PLANNING AND ZONING COMMISSION Tuesday, February 11, 2025, 4:30 PM 191 5th Street West, Ketchum, Idaho 83340

- 4. Recommendation to review and provide feedback on the Sawtooth Serenade Design Review Application (P24-0247)
- <u>5.</u> Recommendation to review and provide feedback on the Knob Hill Residence Pre-Application Mountain Overlay Design Review.

# CITY OF KETCHUM MEETING MINUTES OF THE PLANNING & ZONING COMISSION

COMMENT RESPONSES

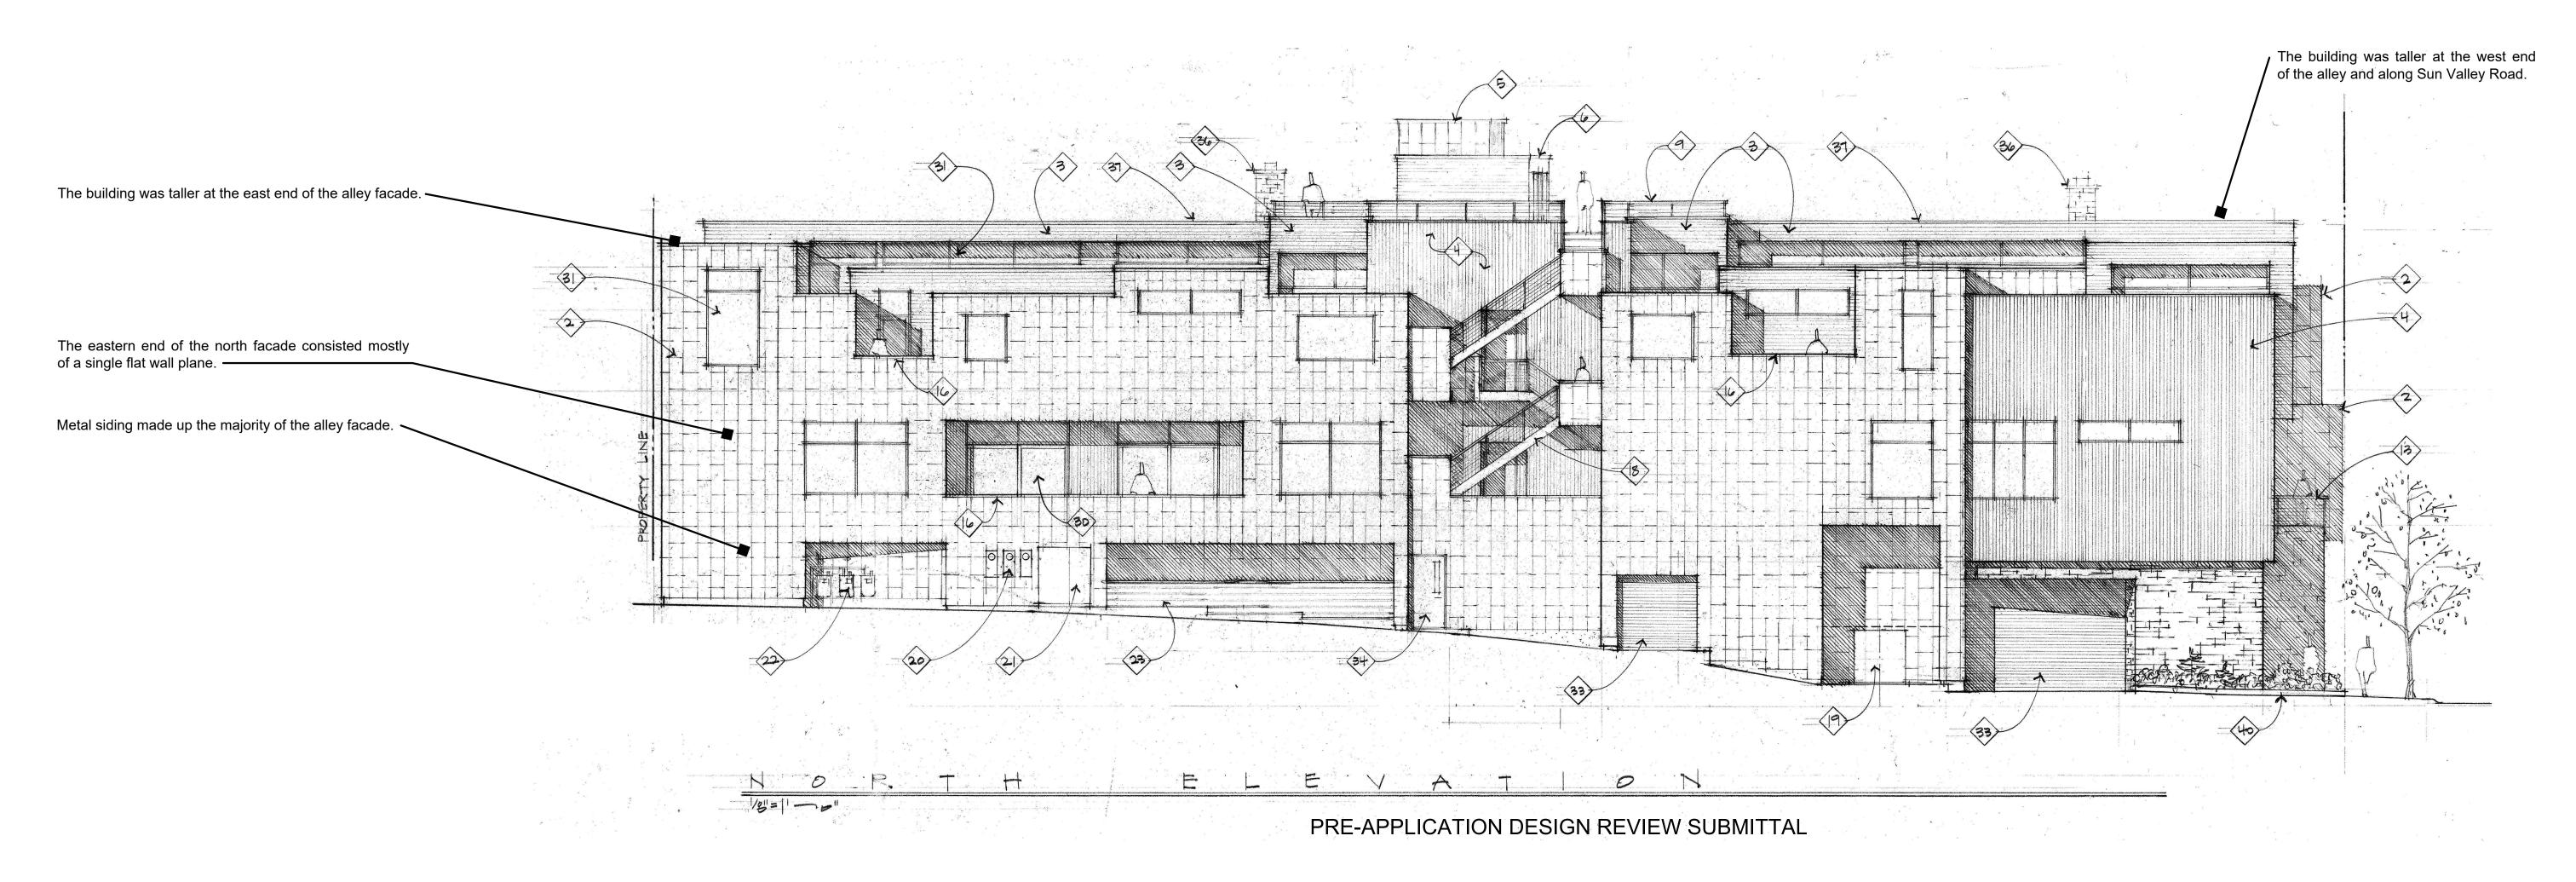
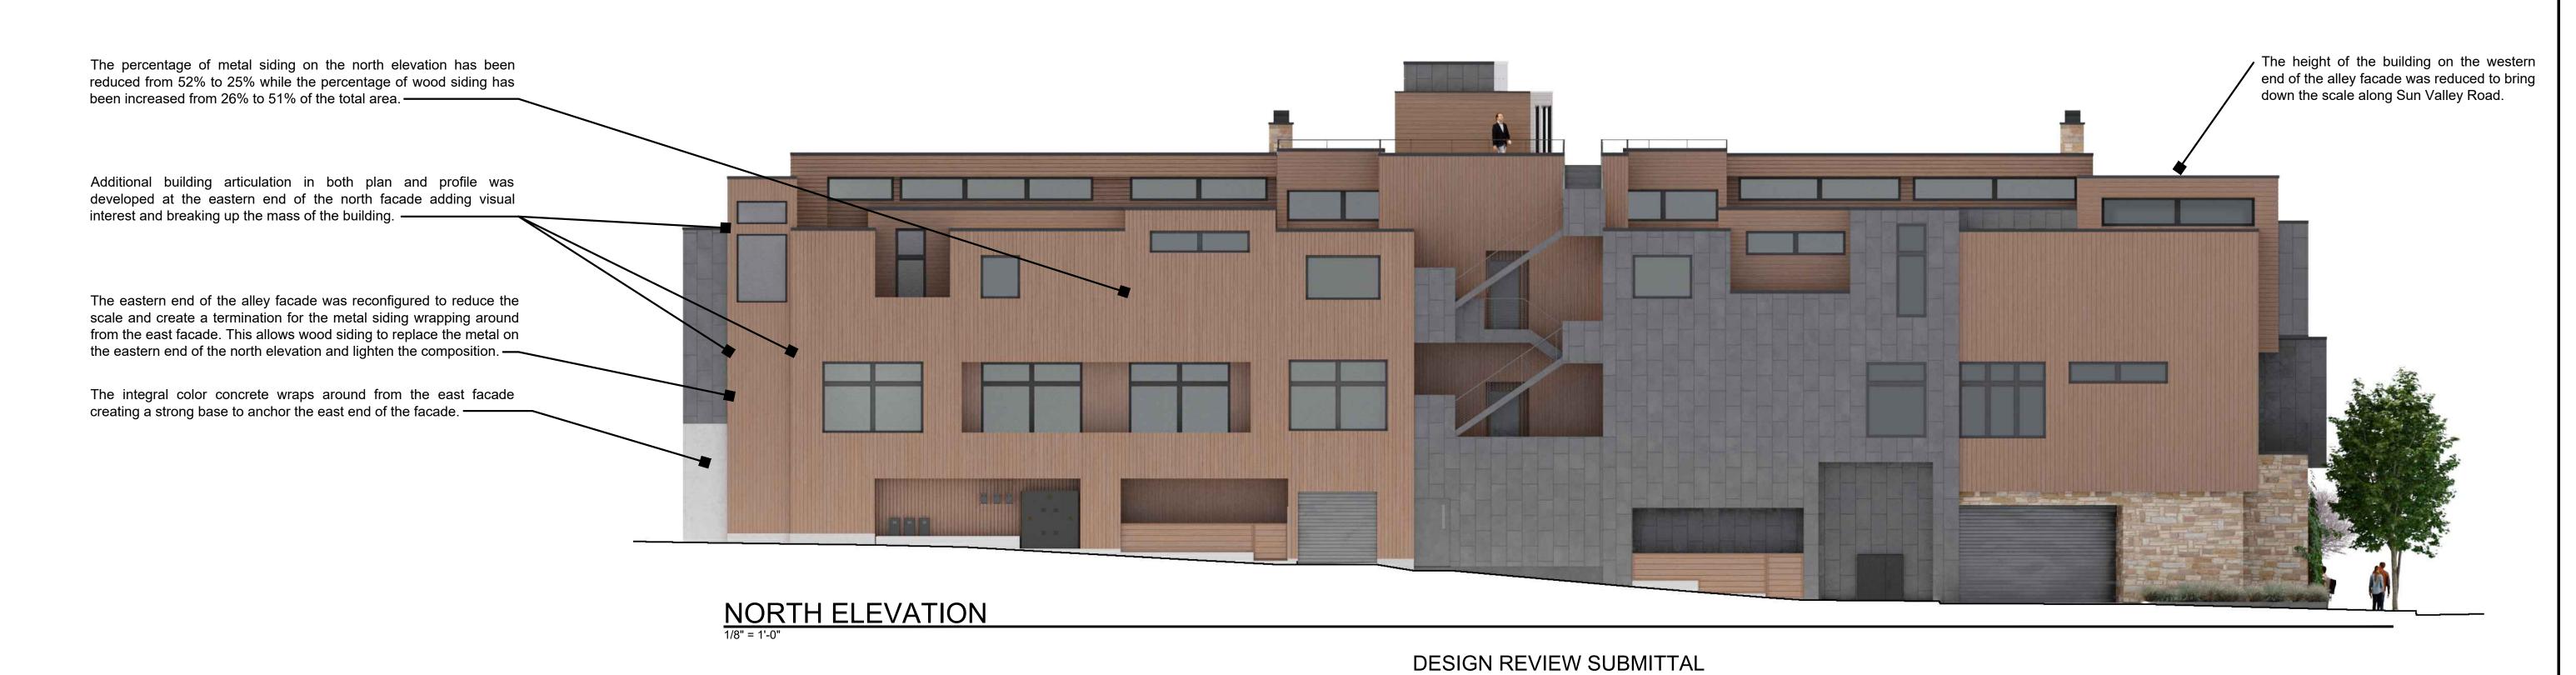
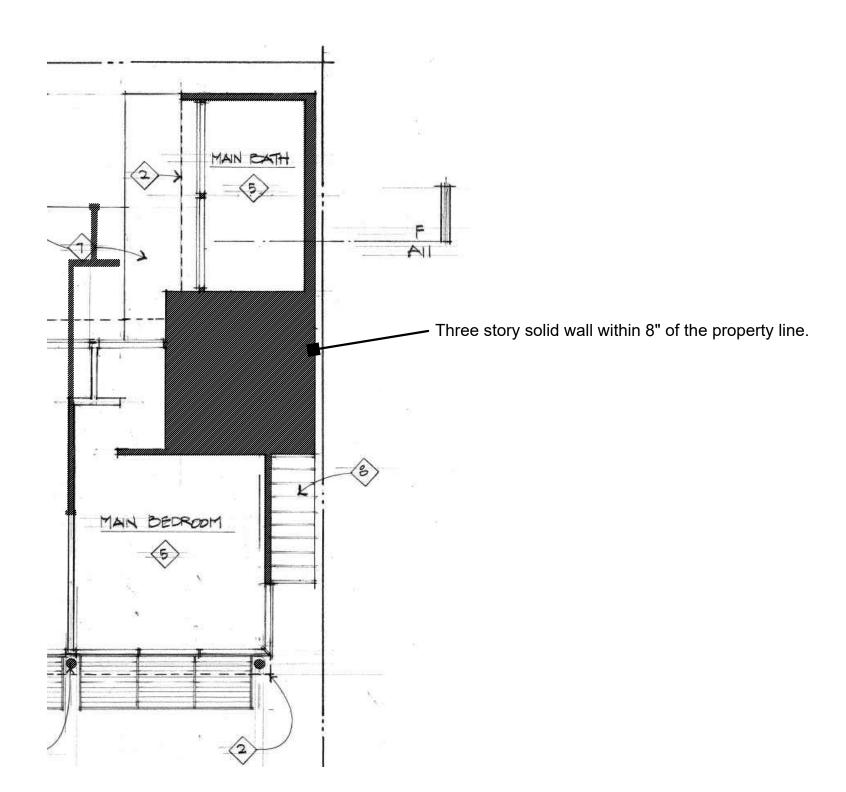
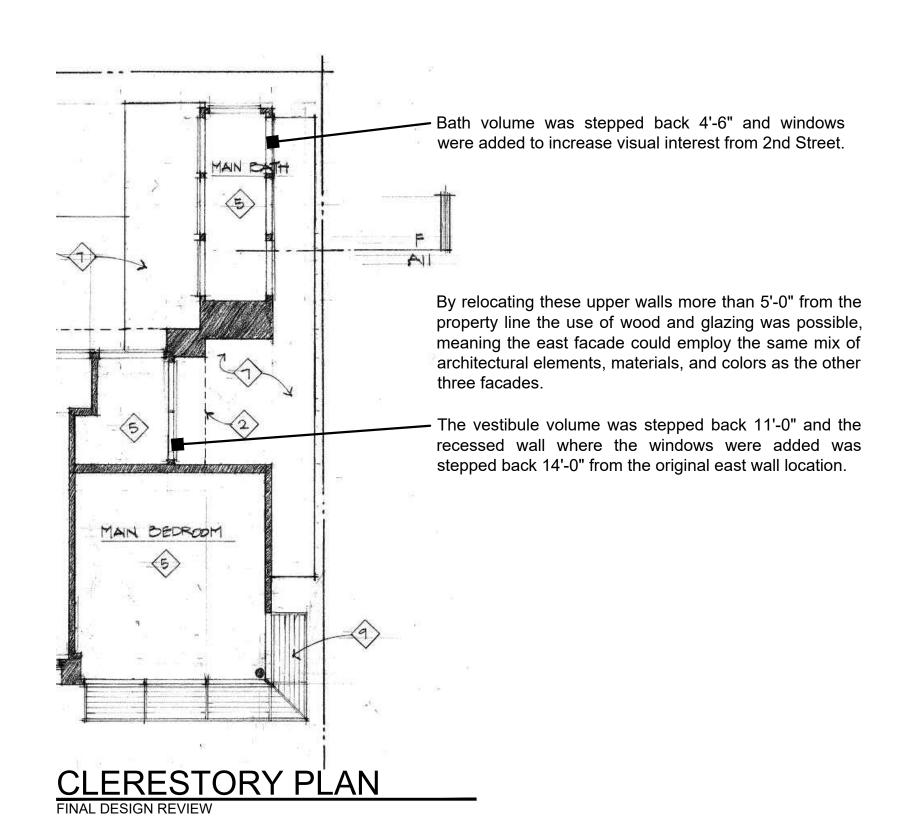
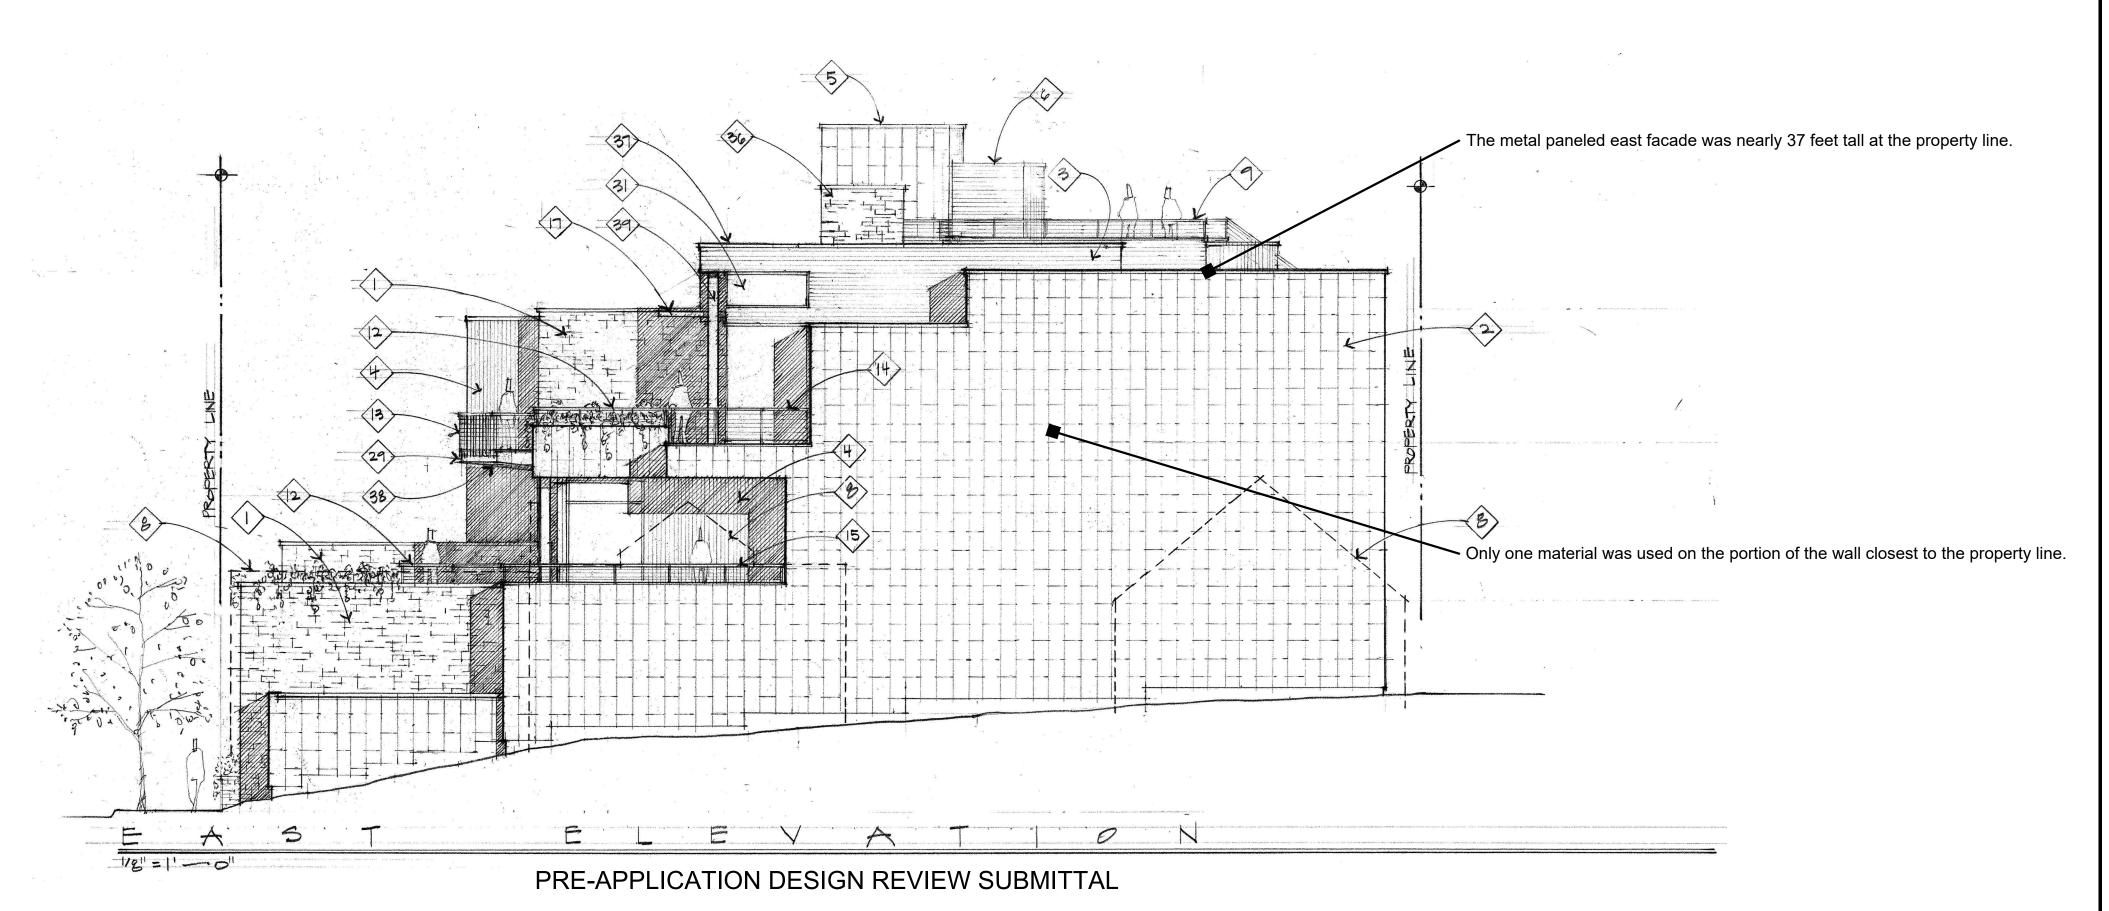
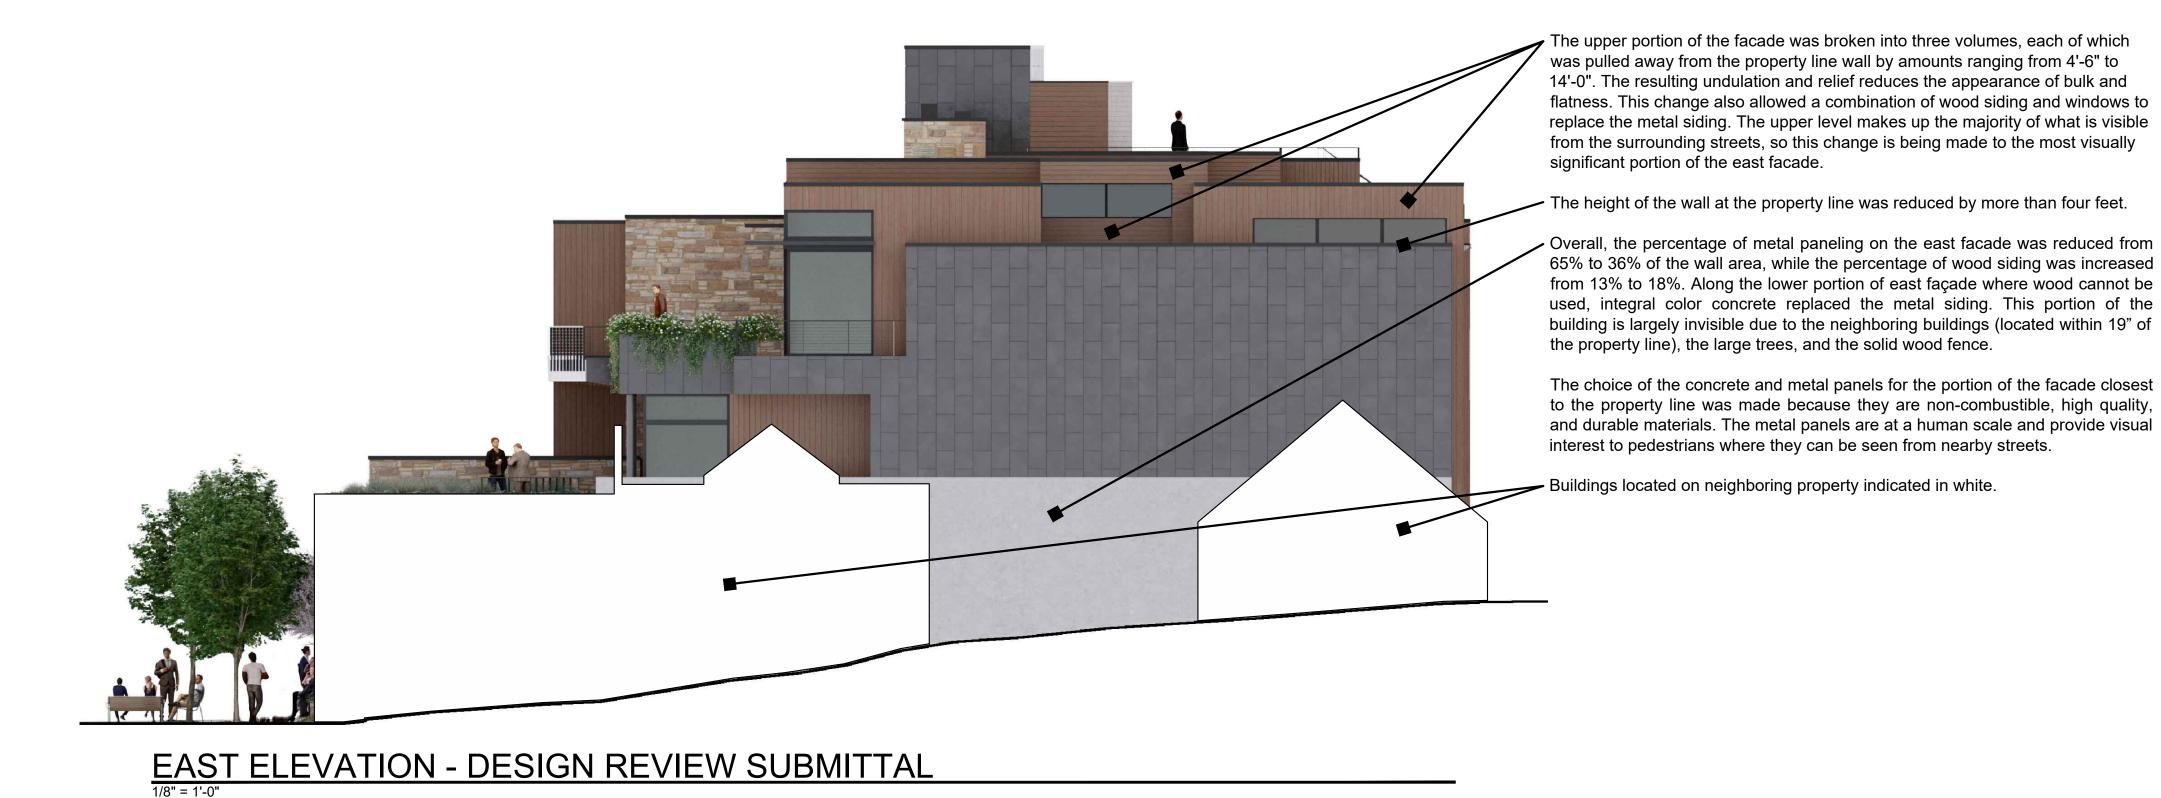
Staff recommends more variation in materials or a step back of the third floor of the building on the east side to reduce the flatness of the facade at that location. - Staff report

Two colors of metal panel, that's all it takes, is to go from black to something, so you don't have to change the material.

- Commission Chair Neil Morrow

Overall, I don't think the mass of the wall on the interior property line is overbearing. - Commission Vice Chair Brenda Moczygemba
